INTERNATIONAL STANDARD ISO/IEC/IEEE 8802-1AX:2016
TECHNICAL CORRIGENDUM 1

TECHNICAL CORRIGENDUM 1

**IEEE Standard for
Local and metropolitan area networks—
Link Aggregation—Corrigendum 1:
Technical and editorial corrections**

Abstract: Technical and editorial corrections are provided in this corrigendum to IEEE Std 802.1AX-2014.

Figure 6-29—Conversation-sensitive collection state diagram

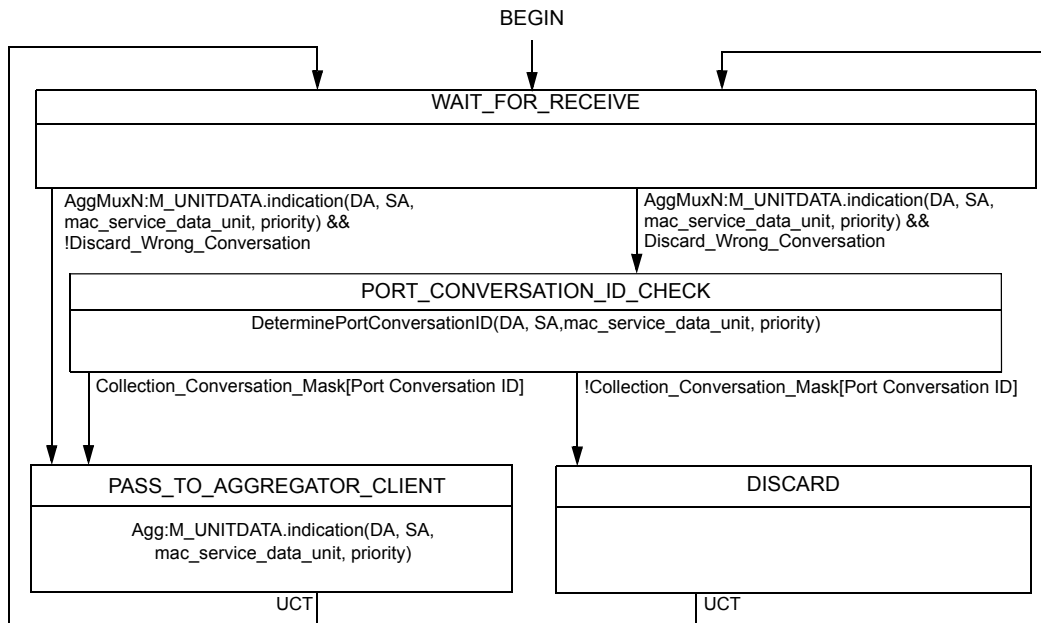
Replace Figure 6-29 with the following:

Figure 6-34—Update Mask state diagram

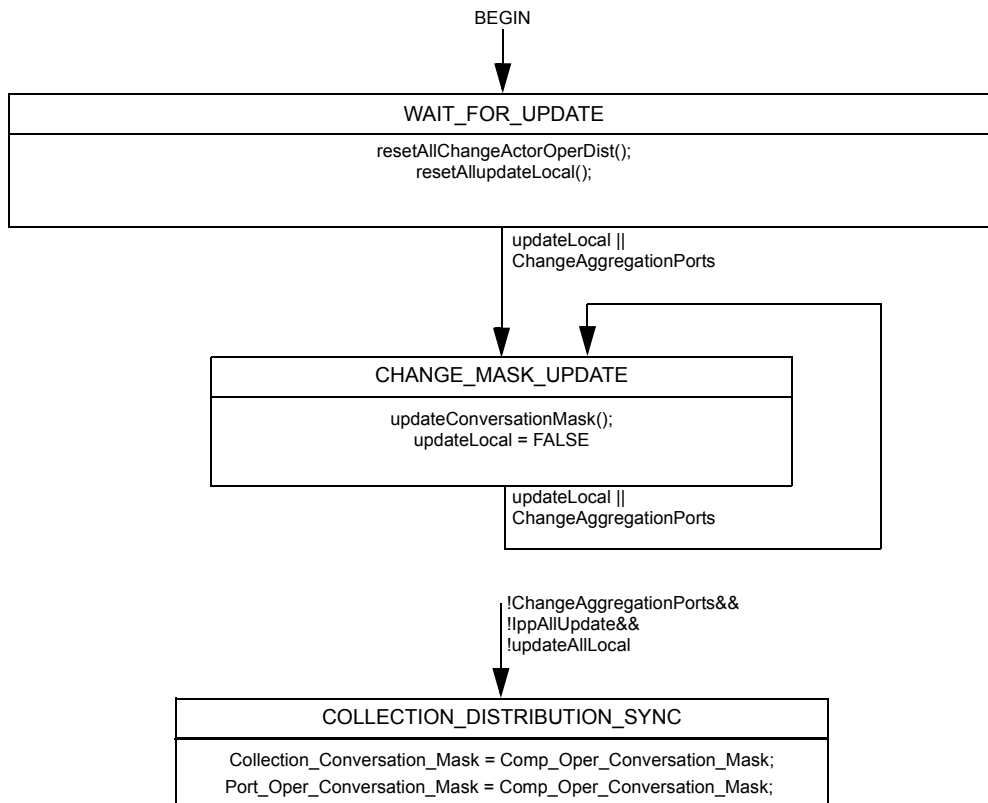
Replace Figure 6-34 with the following:

Figure 6-37—Dual-homed System examples

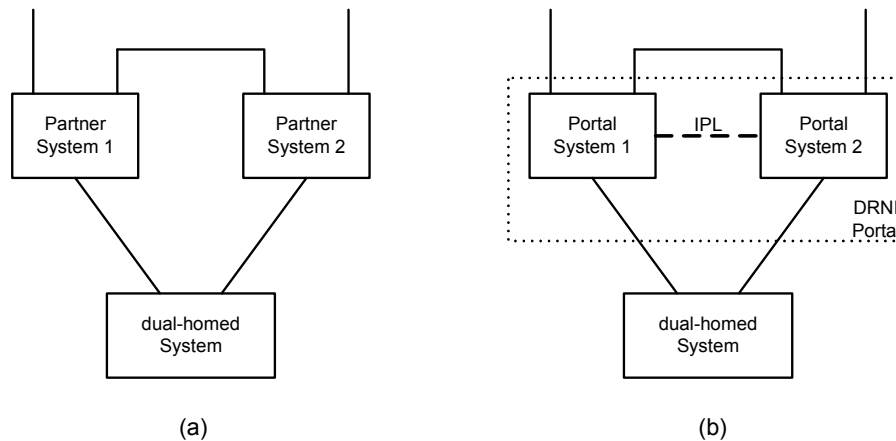
Insert new subclause 6.7.5 as follows:

Figure 6-37 shows two examples of dual-homed systems. In Figure 6-37(a), the dual-homed System is connected to two different Partner Systems. In this case, the two Aggregation Ports cannot select the same Aggregator, and only one Aggregator is available, so the selection logic causes only one Aggregation Port of the set to be selected. The result is a single Link Aggregation Group that includes only one link and connects to only one of the Partner Systems. The Aggregation Port that is not initially selected is held in reserve. Should the link attached to the initially selected Aggregation Port fail, the other Aggregation Port will be selected for a new Link Aggregation Group that again includes only one link but connects to the other Partner System.

In Figure 6-37(b), the dual-homed System is connected to two different Portal Systems in a DRNI Portal (9.1). The normal DRNI operation allows both Portal Systems to present themselves as a single Partner System with the same Operational Key value on both links, resulting in both links become active in a single LAG. If the Intra-Portal Link (IPL) fails, however, the two Portal Systems will use different Operational Key values, which prevents both links from forming a single LAG. In this case, the restriction that the dual-homed system only has a single Aggregator available for these Aggregation Ports results in one Aggregation Port being SELECTED and the other UNSELECTED.
